ATTACHMENT A
PREDEVELOPMENT PLAN REVIEW COMMENTS TO APPLICANT

PREDEVELOPMENT PLAN REVIEW COMMENTS

Project Number: PPR2021-00012, PPR2021-00013 **Date:** February 8, 2022

Project Description: Development of two new single-family residences on undeveloped land

Figure 2: Side Setback Measurement

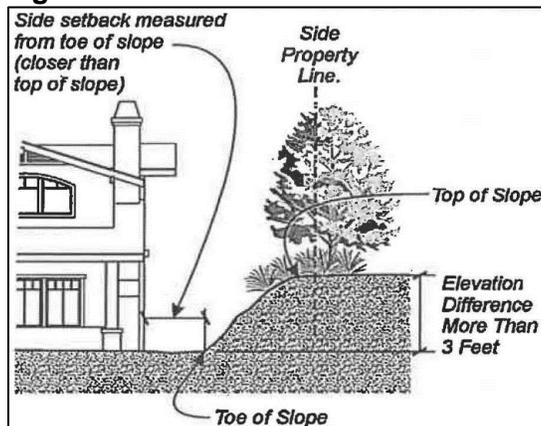
- 3) Side:** The minimum side setback is equal to 10 percent of the lot width, with a minimum of five feet and a maximum of 10 feet (Table 2-3, 17.22.040). In addition, where a building site abuts a lot with an elevation that is three feet or more above or below that of the site, the required side setback shall be measured from the nearest toe or top of slope to the structure, whichever is closer.

According to the plan, the west dwelling provides side setbacks between 15'10" and 34'8". The east dwelling provides side setbacks between 23'4" and 43'11". These setbacks exceed the minimum requirements. However, there is not enough information to determine applicability of Figure 3 above, or compliance with side

setbacks until any private easement for ingress/egress is determined and lot boundaries established/verified.

Figure 3: Encroachment Plane

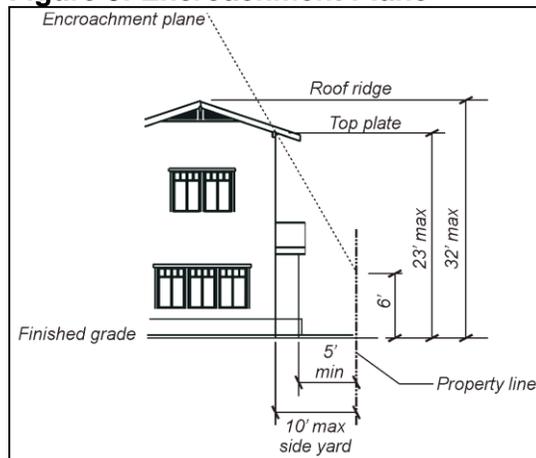
- 4) **Rear:** The minimum rear setback is 25 feet. However, there is not a rear setback. The sites proposed for development have double frontages.
- 5) **Encroachment Plane and Allowed Projections into Setbacks:** Principal structures in the RS zoning district shall not be located within a side setback encroachment plane sloping upward and inward to the site at a 30-degree angle measured from the vertical, commencing six feet above the existing grade along the interior side property lines. However, an attached architectural feature may extend beyond the wall of the structure and into a front, side, or rear setback, and into the encroachment plane pursuant to Table 4-1 (Allowed Projections into Setbacks) and Table 4-2 (Allowed Projections into Encroachment Plane Using RS and RM-12 Standards), Zoning Code Section 17.40.160.

Elevations do not reference the encroachment plane and it is unclear whether any features project or encroach within the setbacks or encroachment plane. At minimum, elevations and sections shall reference the side property line, the encroachment plane, height of commencement, and angle of pitch. All architectural features proposed to project within a setback or encroachment plan shall be dimensioned as part of all future submittals.

Figure 4: Height Measurement

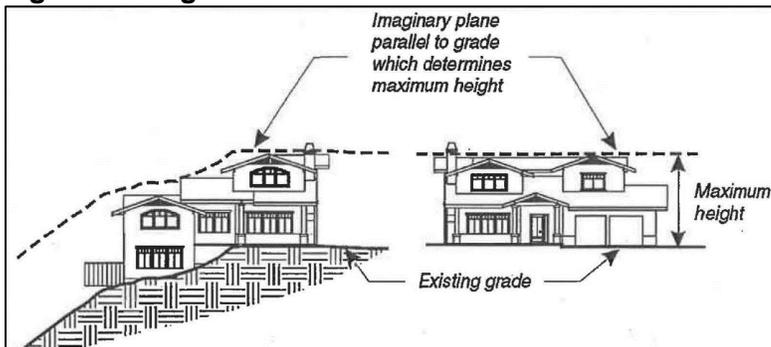
- h) Height Limits ([PMC §17.29.060.B](#), [17.40.060](#)):** No structure shall exceed a height of 28 feet at any point on the site, measured from the existing grade of the site, and shall not exceed a height of 35 feet, measured from the lowest elevation on the site where the structure touches the grade, to the highest point of the roof. There shall be no maximum height for the top plate of a dwelling unit if the general height limit is met. The highest point of the structure shall be considered its highest ridge or parapet. In addition, the vertical distance between the lowest point where the foundation meets grade and the lowest floor line of the structure shall not exceed six feet. No portion of the walking surface of a deck with visible underpinnings shall exceed a height of six feet above grade. Decks shall be integrated into the architecture of the house, and not appear as an add-on to the primary building mass. Refer to Zoning Code Section 17.40.060.D for allowed height limit exceptions (e.g. chimneys).

According to elevations, the garage level is 10 feet tall, with the two stories above the garage adding approximately 26 feet of height. This suggests the aggregate height measured from lowest grade to highest point may be as tall as 36 feet, which exceeds the 35-foot height limit from the lowest elevation. However, there is not enough information to determine actual heights proposed and/or compliance with applicable requirements. The applicant shall demonstrate height complies with the requirements. At minimum, the roof plan shall reference ridge elevations, and existing grade elevations below. Additionally, the lowest elevation of the site where the structure touches the grade shall be clearly identified. Elevations and sections shall demonstrate height and elevations consistently.
